REVISED RESPONSE TO REQUEST FOR ADDITIONAL INFORMATION

APR1400 Design Certification

Docket No. 52-046

RAI No.: 255-8285
SRP Section: 03.08.05 – Foundations
Application Section: 03.08.05
Date of RAI Issue: 10/19/2015

Figure 1 Jurisdictional Boundary for Design of Common Basemat

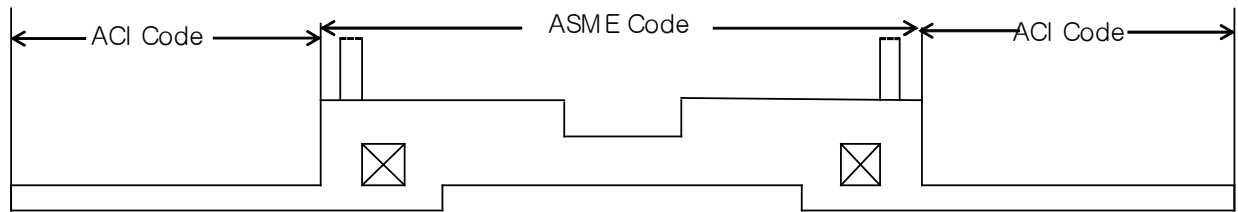
Technical Report (TR) APR1400-E-S-NR-14006-P, Rev 1, "Stability Check for NI Common Basemat," Section 3.2.6, "Load Combinations," states that, "The division of the basemat by code jurisdiction at the thickness transition is a logical choice, and the boundary of the code jurisdiction is conservatively designed using the greater forces from the analysis results of ASME and ACI codes." It is not clear to the staff as to how the applicant consider the loads and load combinations for the basemat of the containment and the Auxiliary building (AB), and how the applicant design the transition region. For example, it is not clear whether the division of the basemat code jurisdiction at the thickness transition is in accordance with the ASME Code Interpretation: 111-2-83-01, which covers this design configuration and how do they define the transition region. Per 10 CFR 50.55a; Appendix A to 10 CFR Part 50, General Design Criteria 1, 2, 4, 16 and 50; and SRP 3.8.5, the applicant is requested to describe in more detail how the loads and load combinations for the basemat of the containment and the AB, were considered in the analysis and how the transition region is design.

Load combinations and load factors for the RCB and the AB basemats are selected based on their relevant design codes, ASME and ACI respectively. The boundary of code jurisdiction between the ASME code and the ACI code is shown in Figure 1. The details of the code jurisdiction boundary are presented in the response to RAI 199-8223, Question 03.08.01-11.

For the design of the basemat, at the interface between the ASME and ACI codes, the lager amount of reinforcement required by either code was used.
